Response to Comments

Remedial Investigation

Crowley Marine Services 8th Ave S. Cleanup Site

July 2024

Appendix B. Figure 1

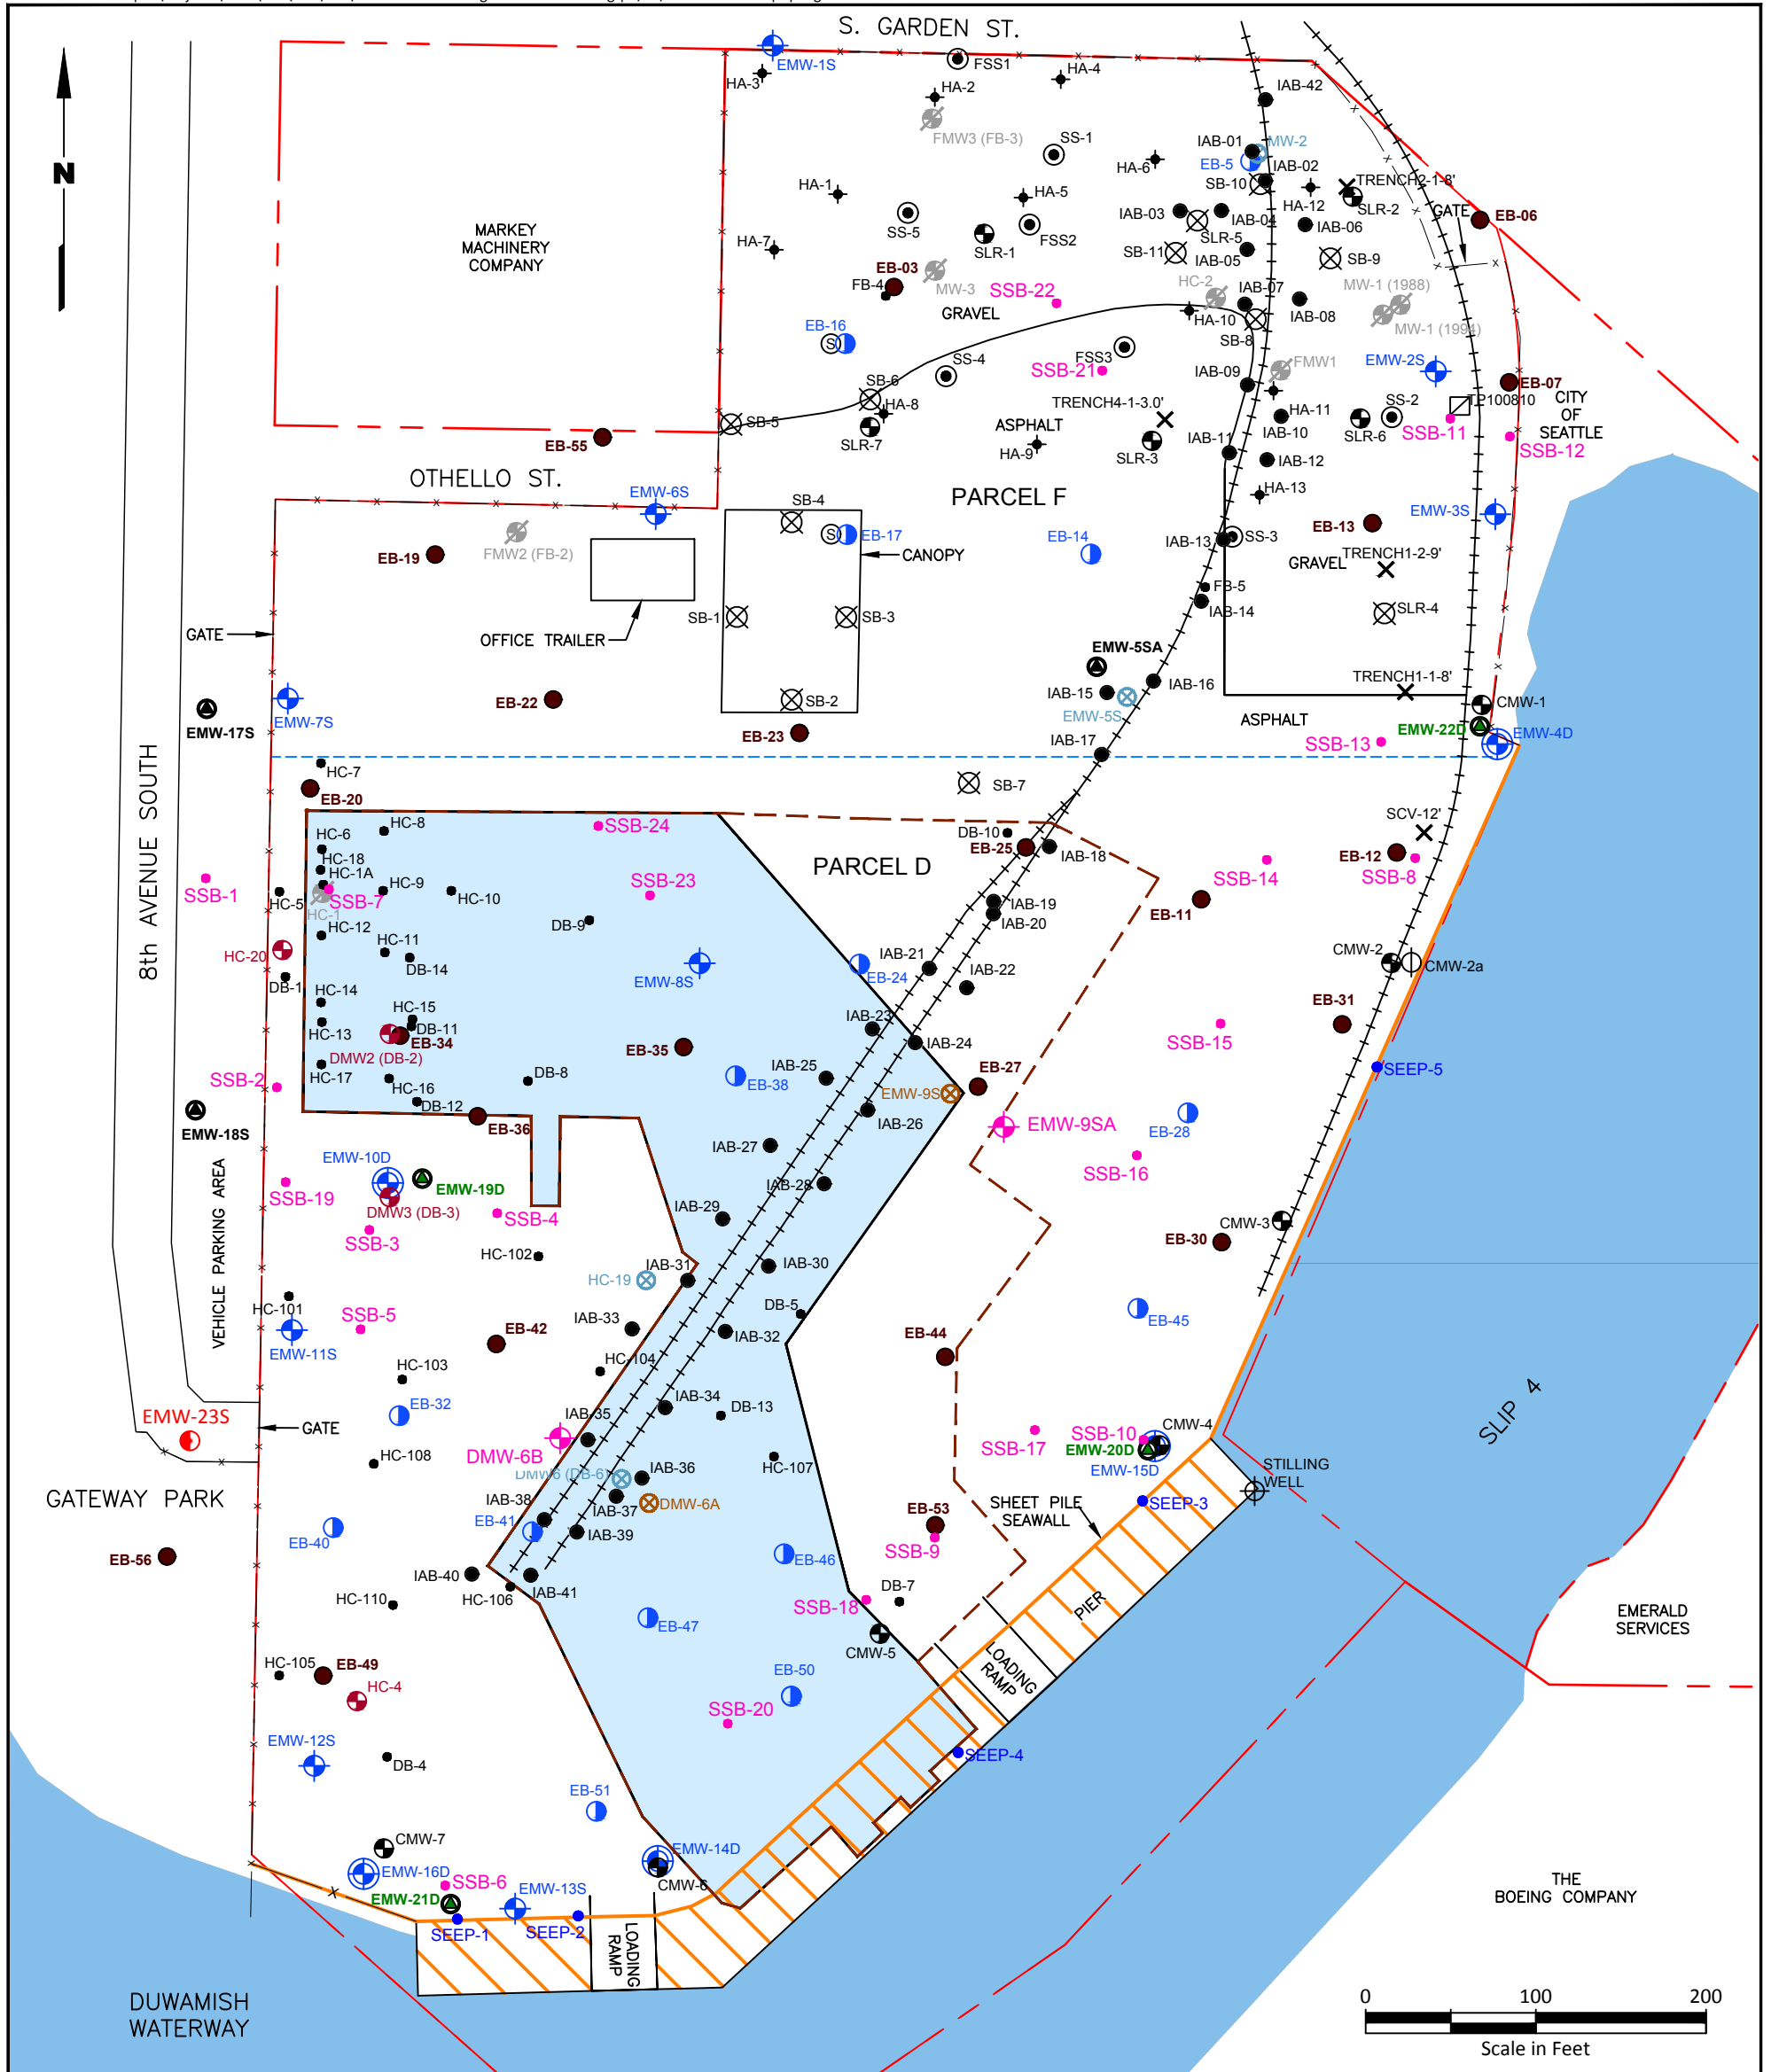
1. **Site releases impacting groundwater in City ROW:** The draft RI shows multiple potential Site releases impacting groundwater in City ROW; however, the draft RI includes only four groundwater monitoring wells in City ROW: EMW-11S, EMW-12S, EMW-17S, and EMW-18S. Please provide the reasoning behind delineating Site-related chemicals with this limited groundwater sampling of the City ROW.

- a. The draft RI states that shallow groundwater flows around the seawall in the SW corner during low tide (Figure 14), but no wells are installed to sample shallow water in this location off property to the SW. The City recommends a shallow groundwater well in City ROW to monitor potential offsite flow of contaminants during the next investigation phase.

In March 2024, a shallow groundwater monitoring well (EMW-23S) was drilled and installed in the City ROW, just north of Gateway Park, to assess the off-property soil and groundwater conditions at that area. The location of EMW-23S is shown on the attached Figure 1. During drilling, a soil sample was collected for laboratory analysis. Groundwater samples were collected from EMW-23S in March and June 2024, and another sampling event will be conducted in September 2024. The results of the 2024 soil sampling and groundwater monitoring activities will be presented in the Addendum to the Public Review Draft FS Report.

As described in the response above to Comment Section 2a, groundwater samples have been collected from the three groundwater monitoring wells in the City ROW in 2020 and/or 2024. In addition, groundwater samples have been collected during the RI and subsequent to the RI from four shallow groundwater monitoring wells (EMW-7S, EMW-11S, EMW-12S, and HC-20) located within 35 feet of the western boundary of the 8th Avenue Terminals property. To evaluate the groundwater conditions that are flowing around the western end of the sheet pile seawall, groundwater samples also have been collected from shallow wells CMW-7 and EMW-12S, from intermediate-depth well EMW-16D, and from deep well EMW-21D. The locations of EMW-7S, EMW-11S, EMW-12S, HC-20, CMW-7, EMW-16D, and EMW-21D are shown on the attached Figure 1. The results of the 2020 groundwater sampling will be included in the Public
